SERVICE BULLETIN

No. 408B

Piper Aircraft Corporation

Flap Outboard Hinge Replacement.

BOTTOM VIEW OF RIGHT WING SHOWN - LEFT WING OPPOSITE

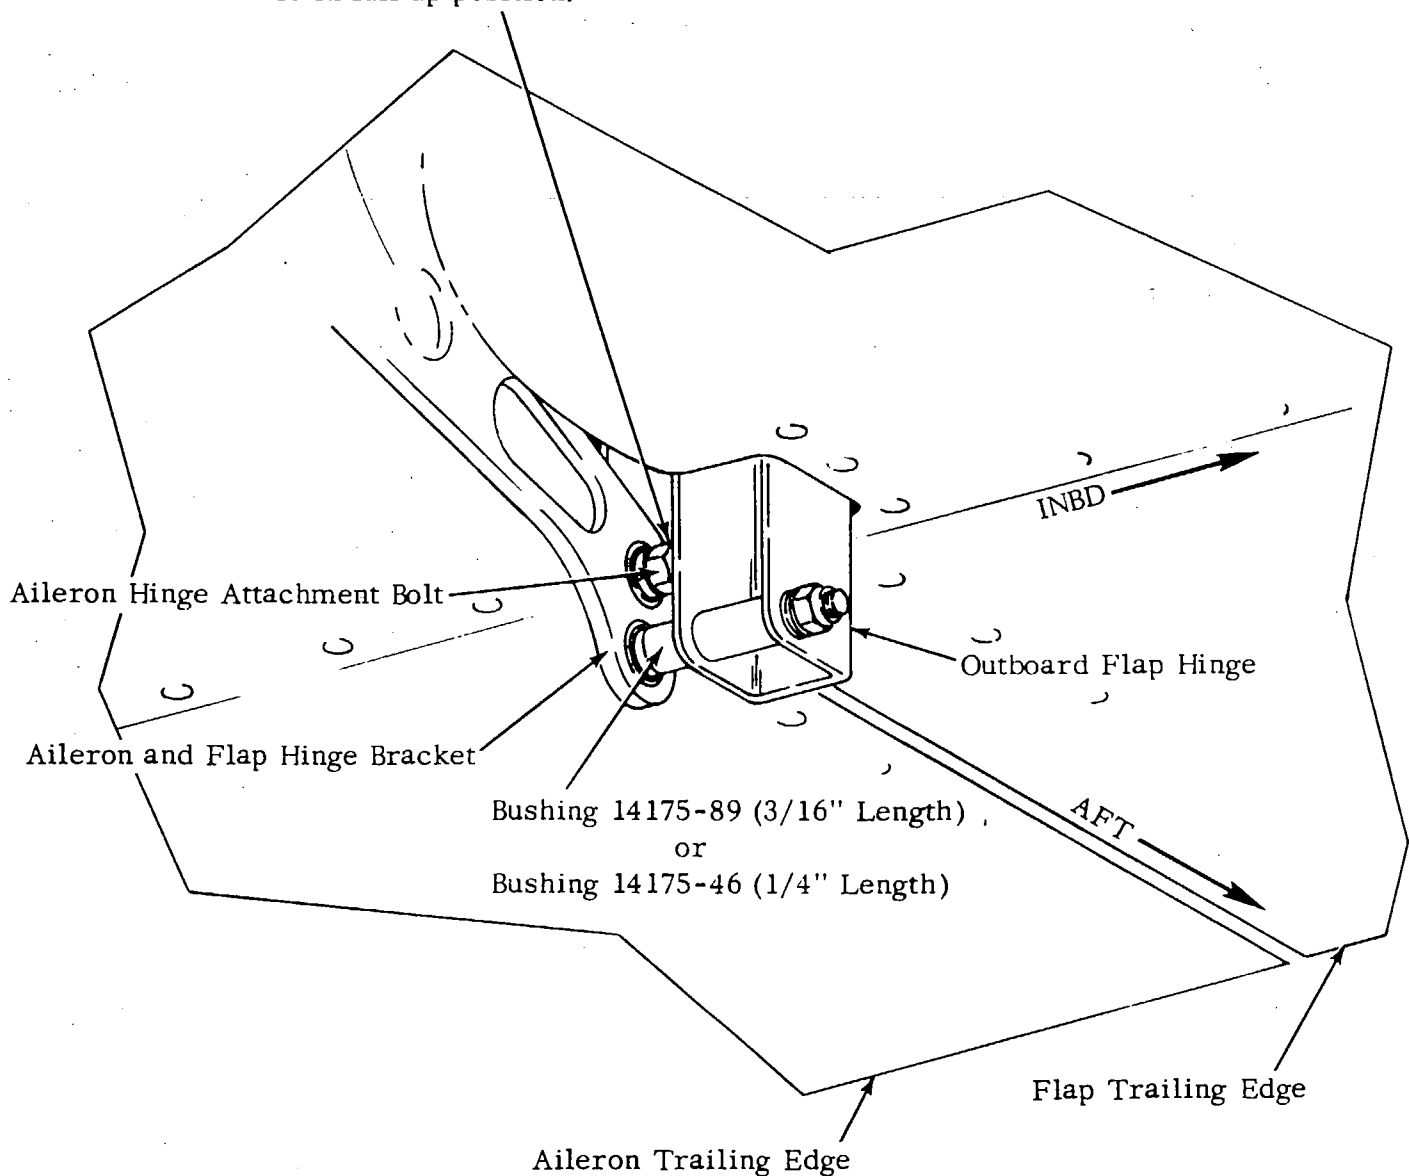
1. Aircraft that have complied with Piper Service Bulletin No. 408A, dated July 1, 1974;
 - A. Inspect the area between the outboard flap hinge and the aileron and flap hinge bracket assembly for proper clearance (refer to attached sketch).

- Inspect area between flap hinge and aileron hinge attachment bolt head to insure that positive clearance exists when flap is in full up position.

- B. If proper clearance exists, no further action is required; make appropriate log book entry.
 - C. If proper clearance does not exist and hinge has been damaged, remove existing bushing and replace with bushing Piper part number 14175-46; replace outboard flap hinge Piper part number 33608-03 (right) and Part Number 33608-02 (left).
